## UNITED STATES PATENT AND TRADEMARK OFFICE

APPLICATION NO.	FILING DATE	FIRST NAMED INVENTOR	ATTORNEY DOCKET NO.	CONFIRMATION NO.	
10/649,051	08/27/2003	Karsten Wieczorek	2000.108400	4956	
23720	7590 01/12/2005		EXAMINER		
	, MORGAN & AMERS	STEVENSON, ANDRE C			
HOUSTON,	MOND, SUITE 1100 TX 77042		ART UNIT	PAPER NUMBER	
,			2812		
				DATE MAILED: 01/12/2005

# **DETAILED ACTION Foreign Priority**

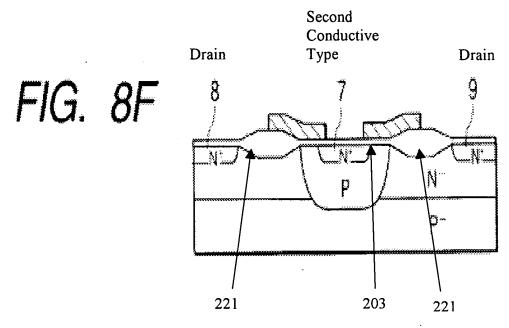
Shimotsusa et al (U.S. Pat 6,825,543 B2), for Claim #12, shows a method, comprising: commonly connecting first conductive regions (gates) of a plurality of circuit elements (transistors) of a semiconductor structure (Fig. 3, item 2, column 10, line 10 through 13) with a first electric potential (V<sub>g</sub>) via (Fig. 3, item 4, column 11, line 29 through 33) a first common contact pad (item 4a, shown below); commonly connecting second conductive regions (item 8, drains) of said plurality of circuit elements (item Tr1) of said semiconductor structure, with a second electric potential (V<sub>DD</sub>) via (item 4c, shown below) a second common contact pad (item 4b, shown below), said first and second

conductive regions being insulated from each other by a dielectric (fig. 8f - 8g); and assessing a reliability of said dielectric by determining failure events of said circuit elements, (column 35, line 31 through 41, line 47 through 54).

Field oxide (221), and gate isolation films (203) See col. 14, lines 46-55.
